NIAGARA MOHAWK POWER CORPORATION

LICENSE NO. DPR-63

DOCKET NO. 50-220

PROPOSED CHANGES TO THE TECHNICAL SPECIFICATIONS (APPENDIX A)

Figure 3.1.7.
NINE MILE POINT UNIT 1
LIMITING POWER FLOW LINE

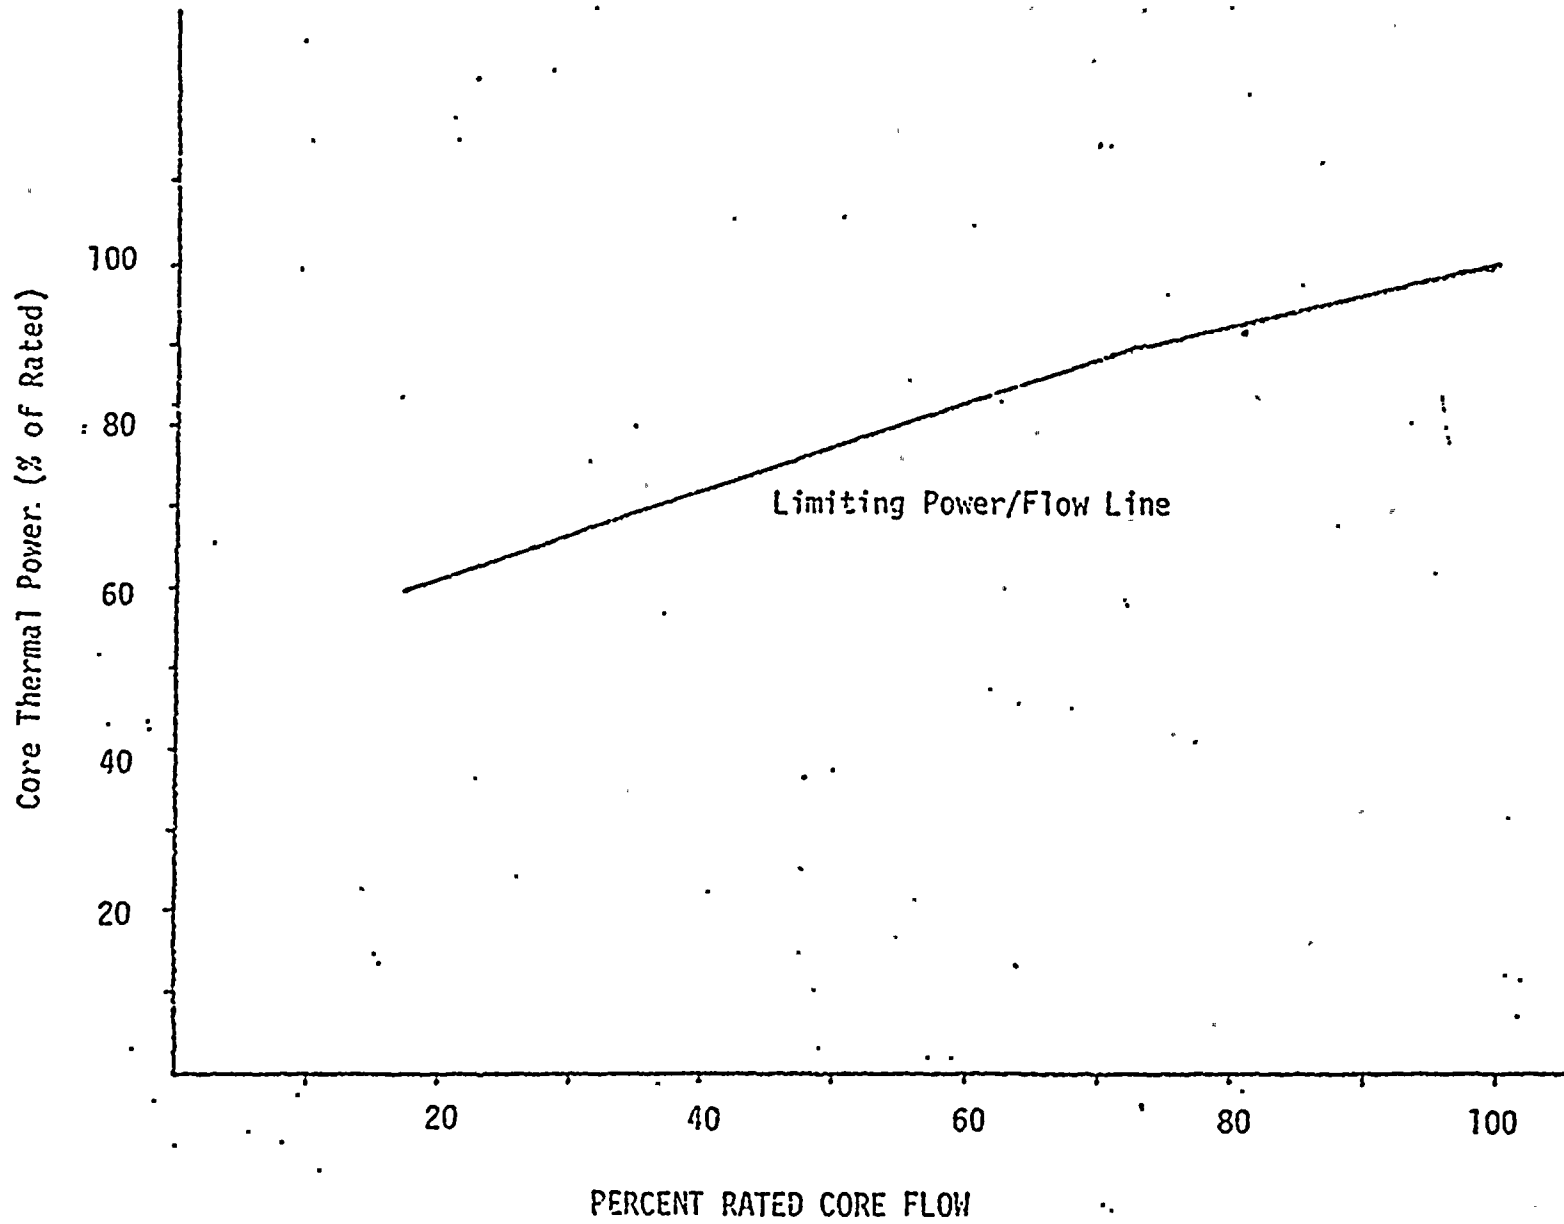
When operating with three or more recirculation loops in operation and the remaining loops unisolated, the reactor may operate at 100 percent of full licensed power level in accordance with Figure 3.1.7aa. No reduction in the APLHGR for each fuel type is required.

When operating with four recirculation loops in operation and one loop isolated, or with three recirculation loops in operation and one loop isolated and the remaining loop unisolated, the reactor may operate at 100 percent of full licensed power in accordance with Figure 3.1.7aa and an APLHGR not to exceed 98 percent of the limiting values shown in Figures 3.1.7a, 3.1.7b, and 3.1.7c, provided the following conditions are met for the isolated loop.

When operating with three recirculation loops in operation and the two remaining loops isolated, the reactor may operate at 100 percent of full licensed power in accordance with Figure 3.1.7aa and an APLHGR not to exceed 96 percent of the limiting values shown in Figures 3.1.7a, 3.1.7b, and 3.1.7c, provided conditions 1 and 2 above are met for the isolated loops. If these conditions are not met, core power shall be restricted to 90.5 percent of full licensed power.
